**IN THE DRAWINGS:**

## REMARKS

This is intended as a full and complete response to the Office Action dated March 31, 2006, having a shortened statutory period for response set to expire on June 30, 2006. Please reconsider the claims pending in the application for reasons discussed below.

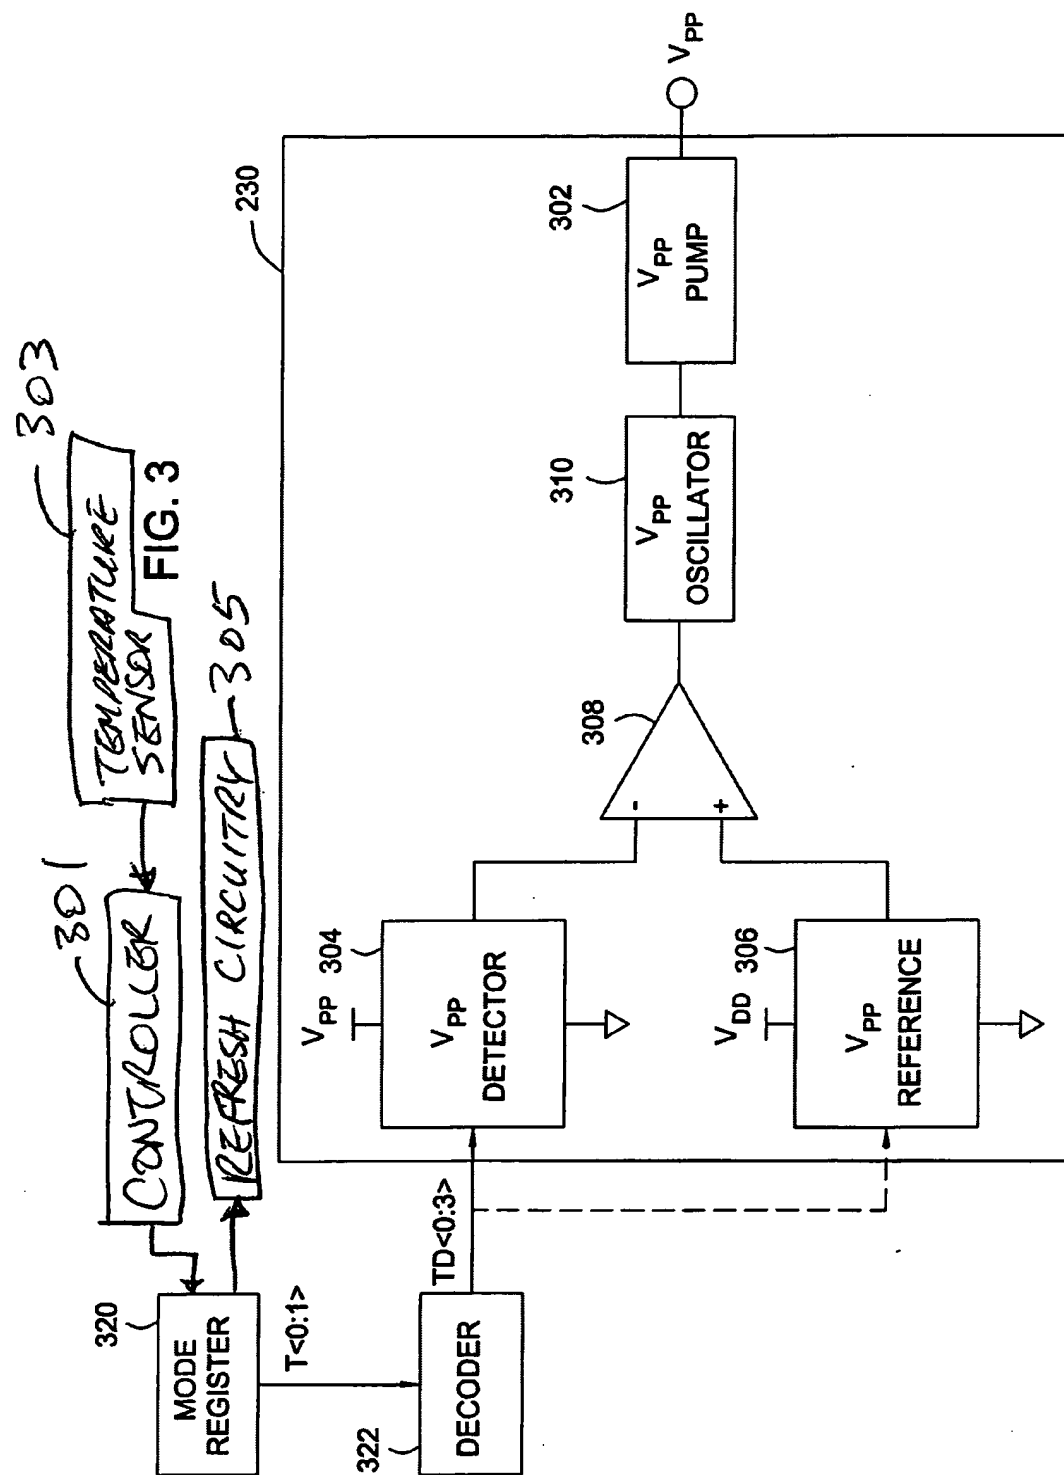
The drawings are objected to under 37 CFR 1.83(a). In Section 1 of the Office Action, the Examiner asserts that Fig. 3 fails to show the external temperature sensor which provides the temperature information. Appropriate amendment to Fig. 3 has been made, as described above. Withdrawal of the objection is respectfully requested.

In Section 2 of the Office Action, The Examiner also requests that the refresh circuitry as recited in claims 3, 17 and 23, the feature as recited in claim 18, an external device as recited in claim 16, and the peripheral circuitry as recited in claim 25 must be shown or the feature(s) canceled from the claim(s). Revised Fig. 3, submitted herewith, shows a temperature sensor, as requested in Section 1 of the subject Office Action. Moreover, Fig. 3 shows refresh circuitry, as requested in Section 2 of the subject Office Action. Applicants submit that Figure 3 also provides support for the feature of claim 18. The controller shown in Fig. 3 may be an external device, as recited in claim 16. The refresh circuitry shown in Fig. 3 represents a peripheral circuitry, as recited in claim 25.

With respect to Claim 1, the Examiner states that it is not clear how obtaining temperature can comprise reading one or more bits in a mode register since Fig. 3 of the present invention does not show any temperature sensor associated with mode register 320. Applicants submit that revised Fig. 3, submitted herewith, shows the requested temperature sensor associated with mode register 320. Withdrawal of the rejection is respectfully requested.

With respect to Claims 3, 17 and 23, the Examiner states that it is not clear how the refresh rate of the memory device can be varied since there is no refresh circuitry is shown in the drawings of the present invention. Applicants submit that revised Fig. 3, submitted herewith, shows the requested refresh circuitry. Withdrawal of the rejection is respectfully requested.

The attached sheets of drawings includes changes to Figs. 3 and 4. Fig. 3 has been amended to depict a controller, a temperature sensor and a refresh circuitry. As far as original support for the temperature sensor and the controller is concerned, support can be found in the specification at least, for example, at Para. [0031], lines 1 to 6. With respect to the refresh circuitry, support can be found in the specification at least, for example, at Para. [0031], lines 3 to 7. Previous Fig. 4 has been replaced with new Figs. 4A and 4B. Reference numbers 304 and 306 have been introduced into the new Figs. 4A and 4B as requested by the Examiner.

Accordingly, it is believed that all elements indicated in Sections 1 and 2 of the subject Office Action are shown in the revised Fig. 3. Withdrawal of the objection is respectfully requested.

FIG. 4B

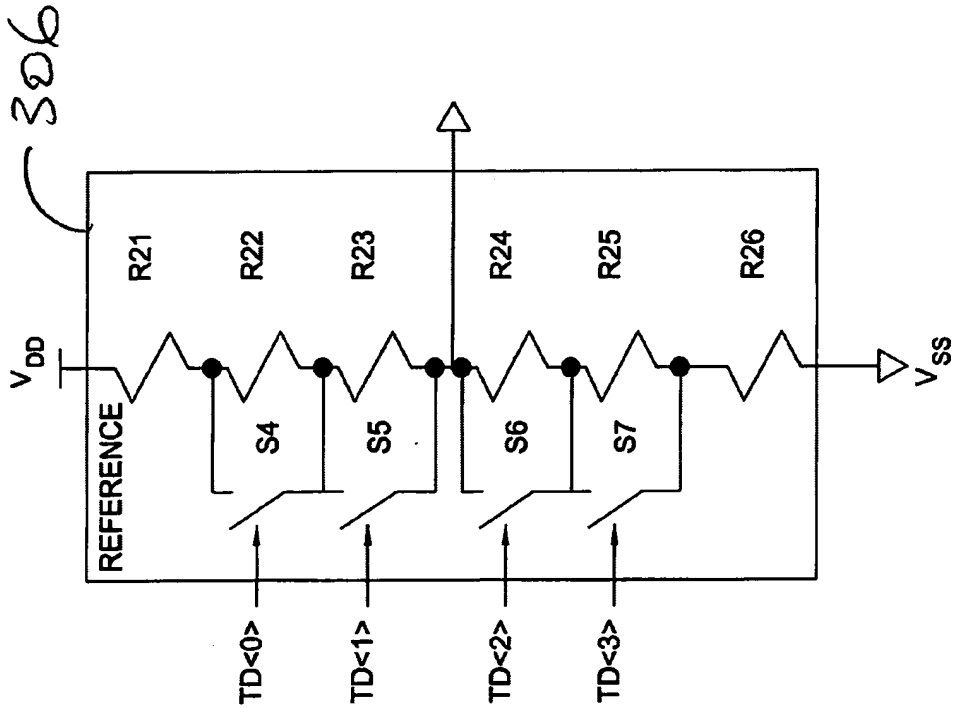
In Section 3 of the Office Action, the Examiner also objects to the drawings as failing to comply with 37 CFR 1.84(p) (5) because they do not include the reference sign(s) 304 (line 8, page 9) and 306 (line 9, page 9) mentioned in the description.

Revised Figs. 4A and 4B, submitted herewith, contain the reference signs requested by the Examiner. Withdrawal of the objection is respectfully requested.
